DART AEROSPACE LTD	Work Order:	91779
Description: Crosstube Assembly (412 High Aft)	Part Number:	D412-664-243
Inspection Dwg: D412-664-243 Rev: E		Page 1 of 2

DRAWING NO. D412-664-243	TITLE CROSSTUBE ASSEMBLY (412 HI AFT)	REV. E	DART AEROSPACE LTD ENGINEERING ORDER		D.E.O. NO. D412-664-243-E-1	SHEET NO. SHEET 1 OF 2	SCALE NTS
DRAWN	CHECKED <i>MP</i>	MFG. APPR. <i>E</i>	APPROVED <i>MP</i>		DE APPR. <i>MP</i>		
DATE 11.03.31	DATE 11/03/31	DATE 11.03.31	DATE 11/03/31		DATE 11-03-31

DRAWING NO. D412-664-243	TITLE CROSSTUBE ASS'Y (412 HI AFT)	REV. E	DART AEROSPACE LTD ENGINEERING ORDER		D.E.O. NO. D412-664-243-E-2	SHEET NO. SHEET 1 OF 1	SCALE NTS
DRAWN <i>MP</i>	CHECKED <i>ASS</i>	MFG. APPR. <i>EE</i>	APPROVED <i>MP</i>		DE APPR. <i>MP</i>		
DATE 11.09.07	DATE 11.09.19	DATE 11.09.19	DATE 11.09.19		DATE 11.09.19

DRAWING NO. D412-664-243	TITLE CROSSTUBE ASSEMBLY (412 HI AFT)	REV. E	DART AEROSPACE LTD ENGINEERING ORDER		D.E.O. NO. D412-664-243-E-4	SHEET NO. SHEET 1 OF 3	SCALE NTS
DRAWN 90	CHECKED J	MFG. APPR. A	APPROVED MP		DE APPR. MP		
DATE 12.08.21	DATE 12.08.30	DATE 12.08.30	DATE 12/8/30		DATE 12.08-30

**D412-664-243
ASSEMBLY DETAIL**

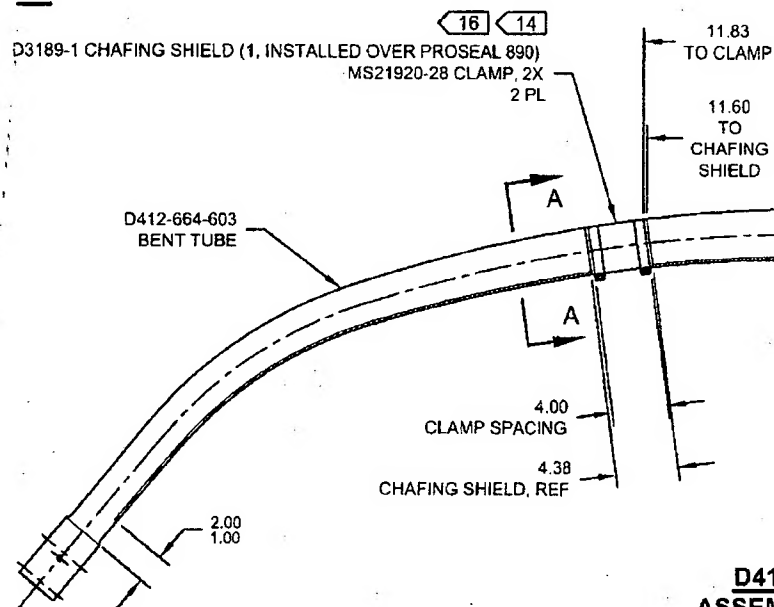
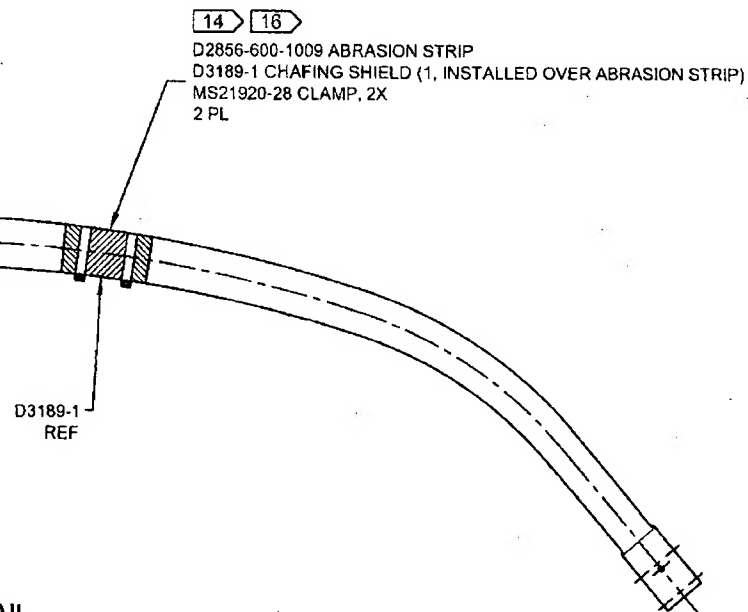
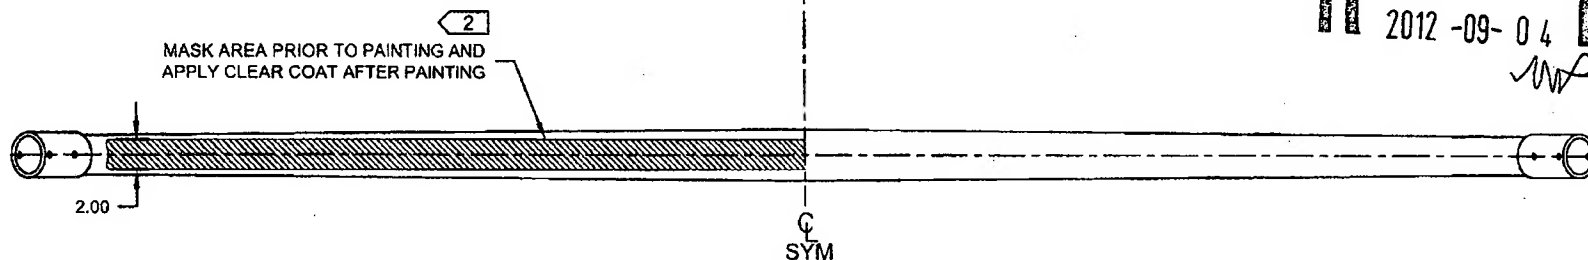
PURPOSE:

REMOVED ABRASION STRIP IN FAVOR OF A THIN LAYER OF PROSEAL 890. UPDATE INSTALLATION OF CHAFING SHIELDS AND REDUCE TORQUE TO 40-50 IN-LBS. THIS ENGINEERING ORDER SUPERCEDES DEO D412-664-243-E-1.

NOTES 2, 14, AND 16 ON SHEET 1 ARE AMENDED AS FOLLOWS:

IS:

- 2) FINISH: CHEMICAL CONVERSION COAT PER DART QSI 005 4.1
PRIME INSIDE AND OUTSIDE PER DART QSI 005 4.2
MASK UNDERSIDE OF CROSSTUBE AS SHOWN (HATCHED AREA)
PAINT OUTSIDE PER DART QSI 005 4.2
AFTER PAINTING, APPLY CLEAR COAT ON HATCHED AREA
- 14) APPLY A THIN COAT OF PROSEAL 890 ON INSIDE CONCAVE SURFACE OF D3189-1 CHAFING SHIELD AND LET CURE PER MANUFACTURER'S INSTRUCTIONS. INSTALL PROSEALED D3189-1 CHAFING SHIELD ONTO CROSSTUBE BY APPLYING A THIN COAT OF PROSEAL 890 ONTO CROSSTUBE. BE SURE TO ELIMINATE ANY AIR GAPS.
- 16) TORQUE CLAMPS ON D2896-1 SUPPORT 80 TO 100 IN-LB. **TORQUE CLAMPS ON D3189-1 CHAFING SHIELD 40 TO 50 IN-LB.** ENSURE AT LEAST 1.5 THREADS SHOWING IN SAFETY AND THAT NUT HAS NOT BOTTOMED-OUT AFTER TORQUING.

WAS:

- 2) FINISH: CHEMICAL CONVERSION COAT PER DART QSI 005 4.1
PRIME INSIDE AND OUTSIDE PER DART QSI 005 4.2
PAINT OUTSIDE PER DART QSI 005 4.2
- 14) INSTALL D2856-600-1009 ABRASION STRIPS WITH A 0.13 REF GAP ON BOTTOM SIDE OF CROSSTUBE PER QSI 035.
- 16) TORQUE CLAMPS 80 TO 100 IN-LB. ENSURE AT LEAST 1.5 THREADS SHOWING IN SAFETY AND THAT NUT HAS NOT BOTTOMED-OUT AFTER TORQUING.
